UNITED STATES
NUCLEAR REGULATORY COMMISSION
WASHINGTON, D. C. 20555

TURKEY POINT PLANT UNIT NO. 3

ATTACHMENT TO LICENSE AMENDMENTS

SAFETY EVALUATION BY THE OFFICE OF NUCLEAR REACTOR REGULATION
RELATED TO AMENDMENT NO. 94 TO FACILITY OPERATING LICENSE NO. DPR-31
AND AMENDMENT NO. 88 TO FACILITY OPERATING LICENSE NO. DPR-41
FLORIDA POWER AND LIGHT COMPANY
TURKEY POINT PLANT UNIT NOS. 3 AND 4
DOCKET NOS. 50-250 AND 50-251

FIGURE 6.2-1 OFFSITE ORGANIZATION FOR FACILITY
MANAGEMENT AND TECHNICAL SUPPORT

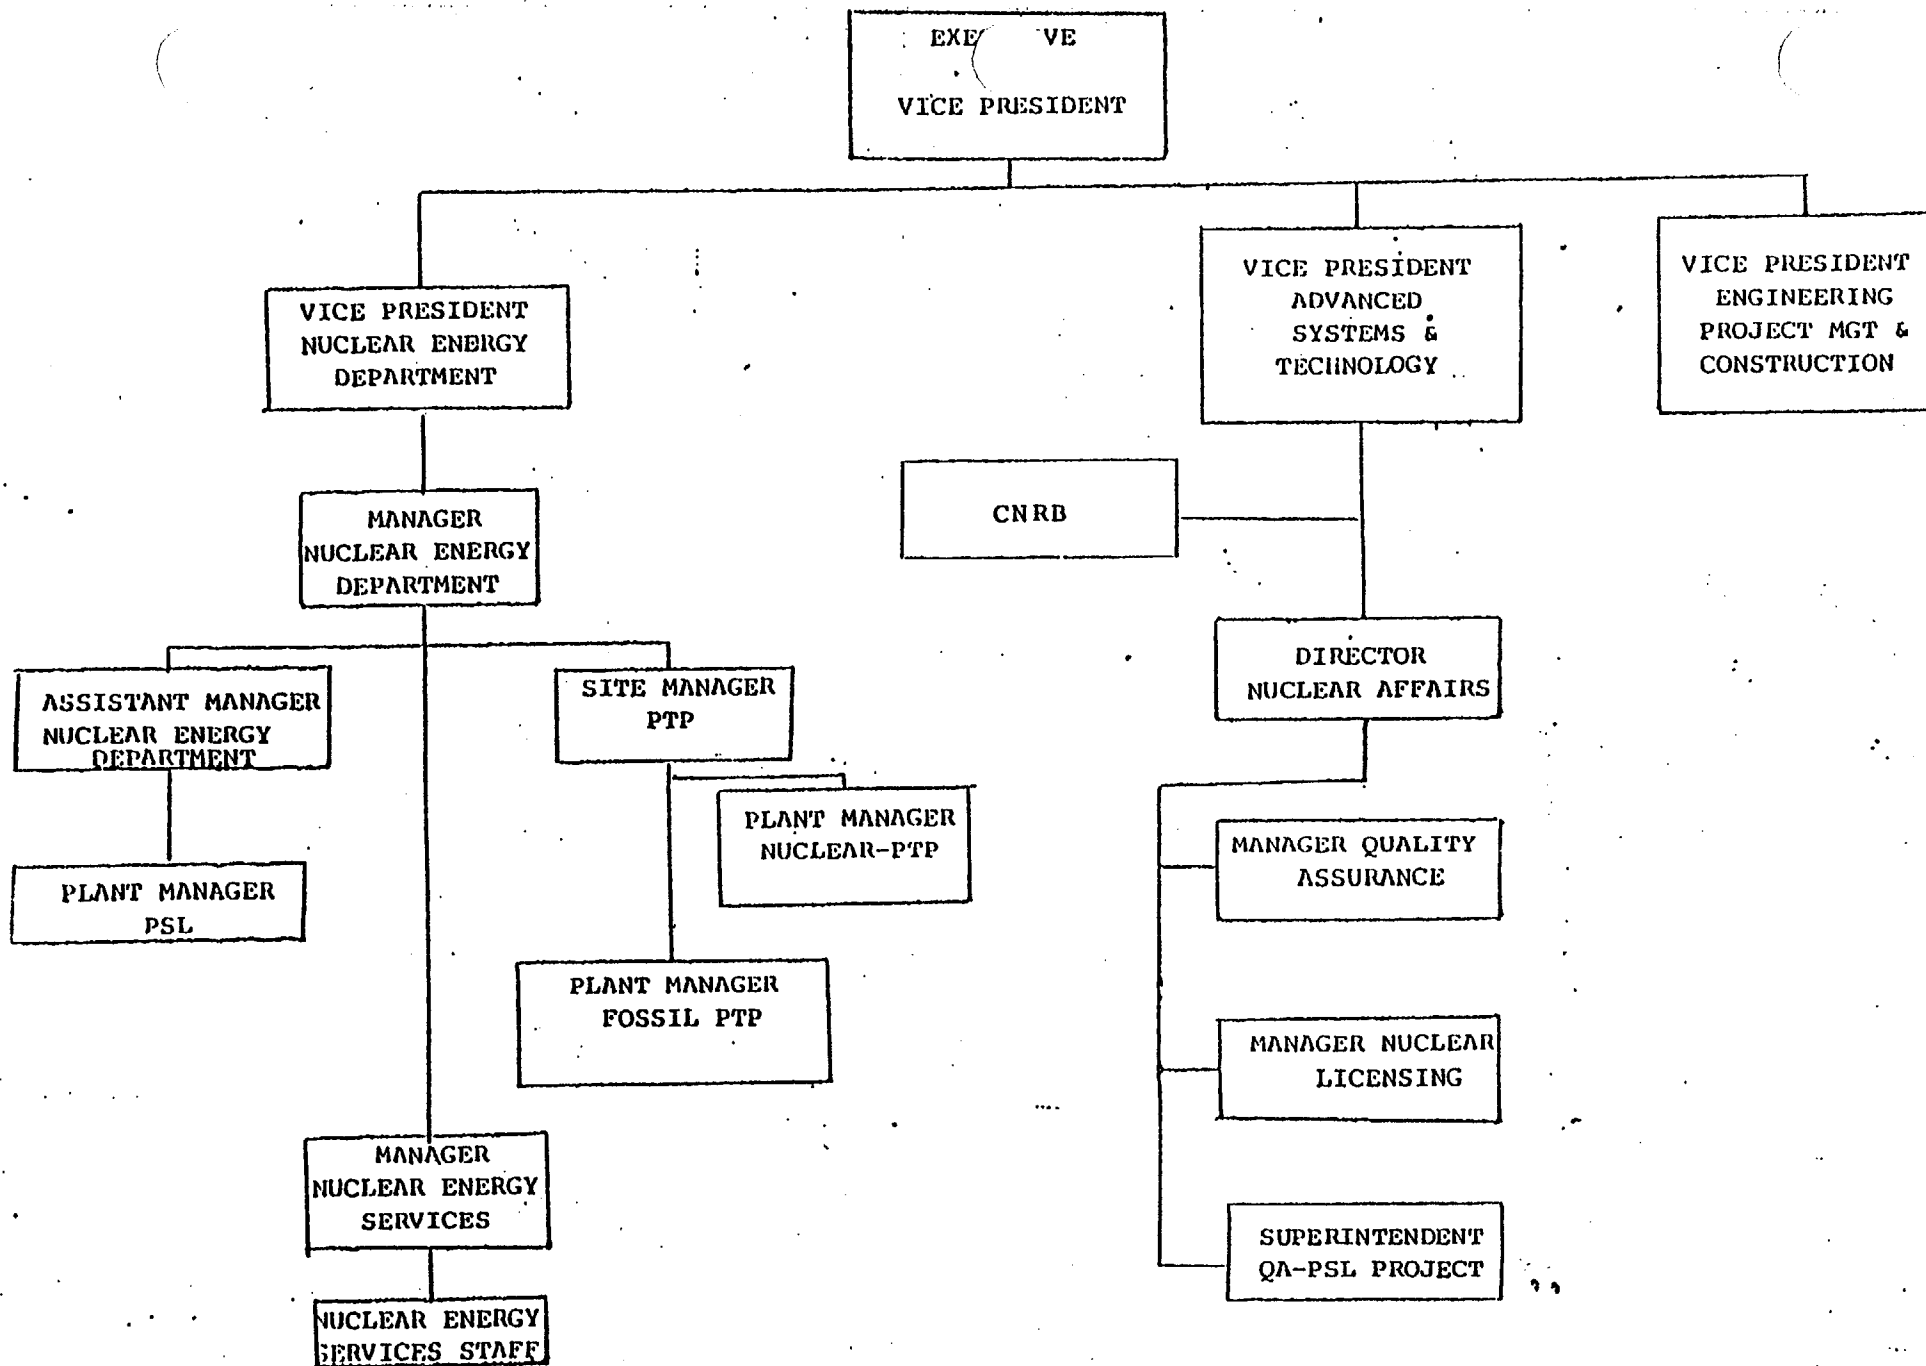
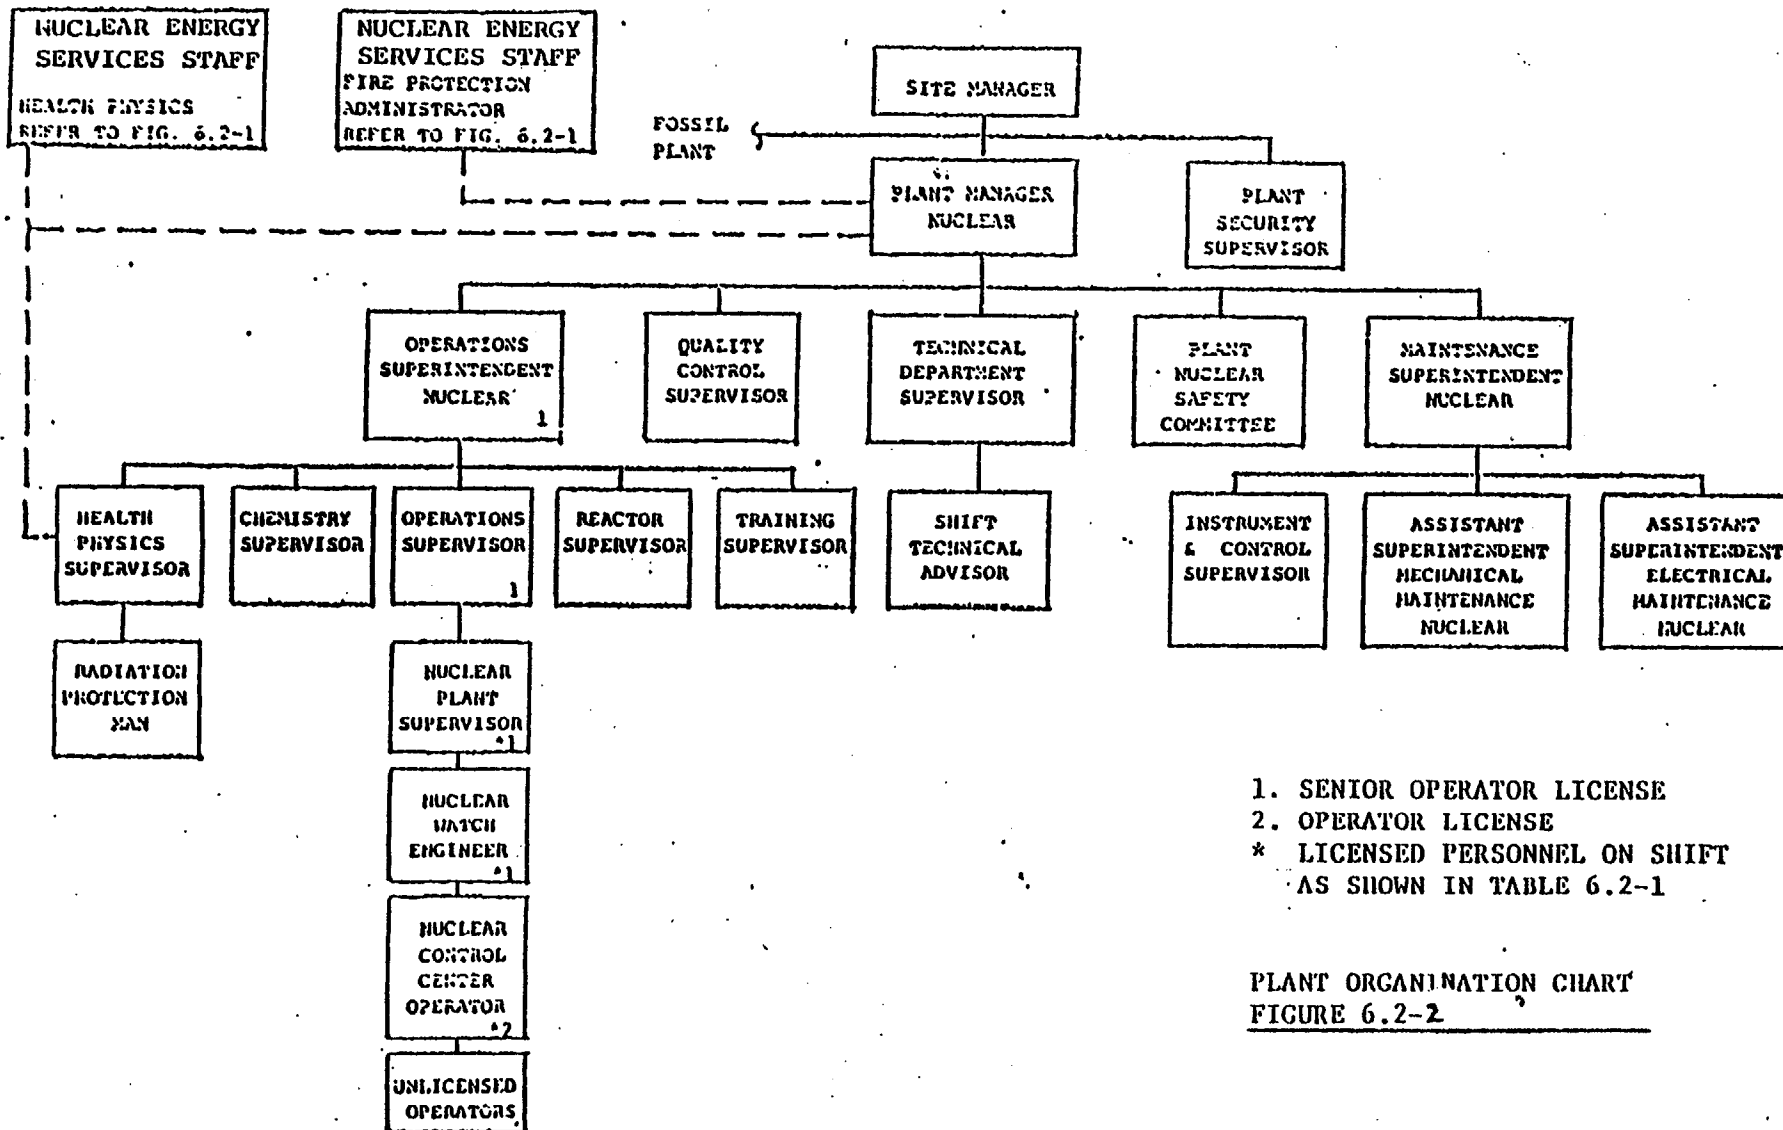
The licensee proposes to modify Figure 6.2-1, "Offsite Organization for Facility Management and Technical Support" to show that a Nuclear Energy Department (NED) has been formed to manage the nuclear activities that were previously managed by the Power Resources Department. The new NED is headed by a Vice President who reports directly to the FPL Executive Vice President. Reporting to the new Vice President-NED is a Manager-NED, a position that was previously titled Manager-Power Resources-Nuclear and that previously reported to the Vice President-Power Resources. The Site Manager and the Manager-Nuclear Engineering Services (title changed from Manager-Power Resources Nuclear Services) and a new position titled Assistant Manager NED report to the Manager-NED.

We conclude that the organization structure changes as discussed above does not diminish FPL's ability to safely operate the Turkey Point Units 3 & 4 and the proposed modifications to Figures 6.2-1 and 6.2-2 to reflect these changes are acceptable.
